Boldon Colliery,
Brain Injury Rehabilitation Service

Minor Design Amendment
Prepared for South Tyneside Borough Council

January 2025

Excerpt of marked up Elevation issued by South Tyneside Council

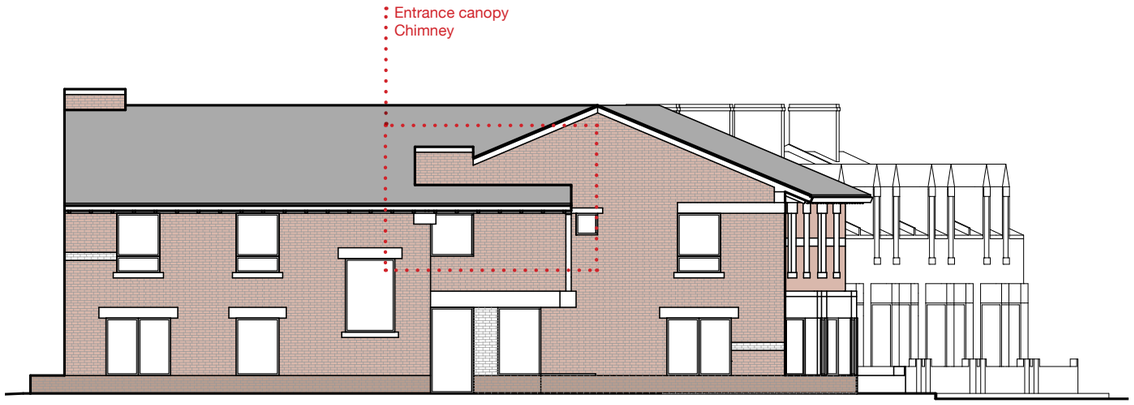
> *Design – can you see if any improvements could be made to the appearance of the southern elevation, for the part marked up on the attached PNG file, as that part has a bit of a clumsy appearance?*

The following pages aim to address the comment raised, justify the design proposal and propose an amendment to strengthen the design.

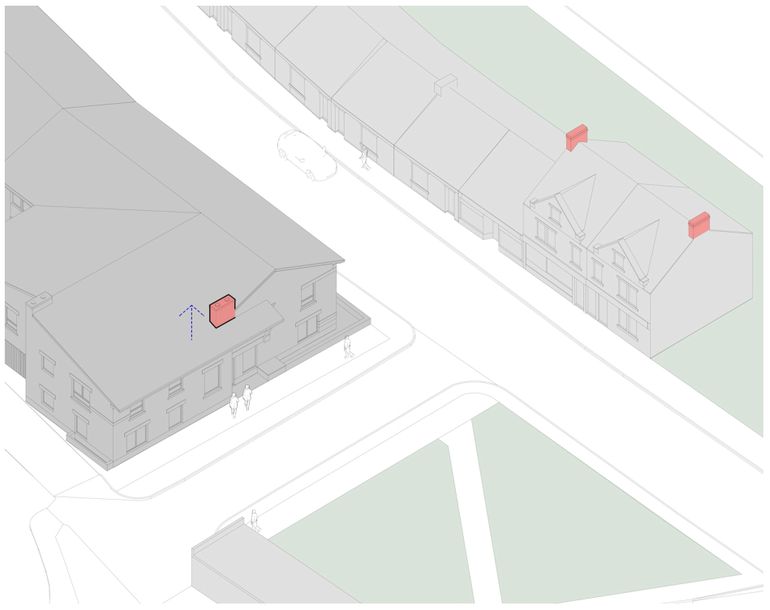
6. Chimney height increased in response to comments

Amended Proposed South Elevation

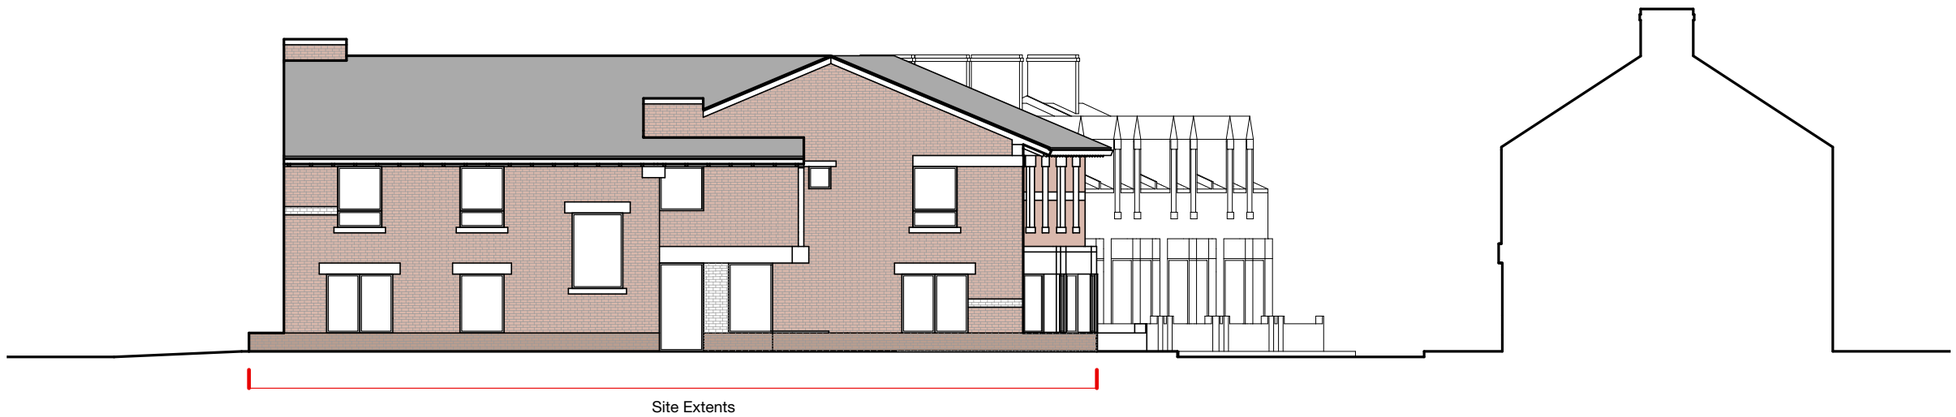
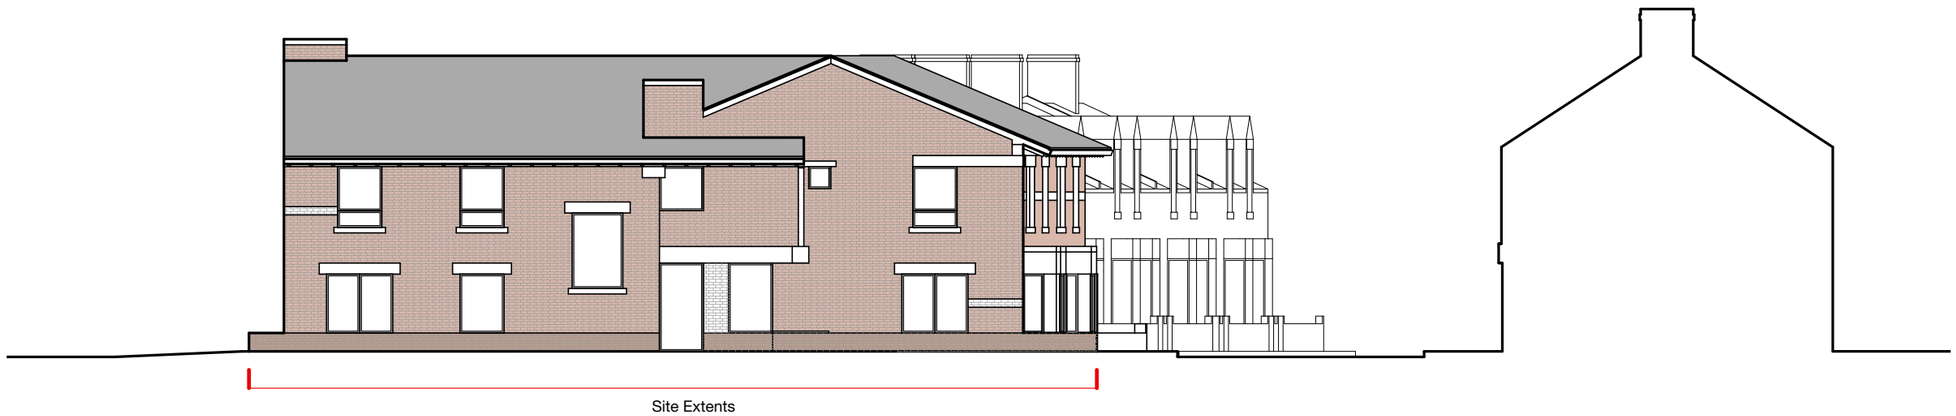
In Summary, the amendment to the height of the chimney has been proposed in order to:

- define the entrance
- tie into the ventilation strategy of the building
- reference the proportions of the neighbouring buildings
- further separate the chimney from the entrance canopy

Through this design analysis and further study of the adjacent buildings, we have increased the height of the chimney. We believe this gives more prominence to the entrance by elongating its proportions, separating it further from the entrance canopy.
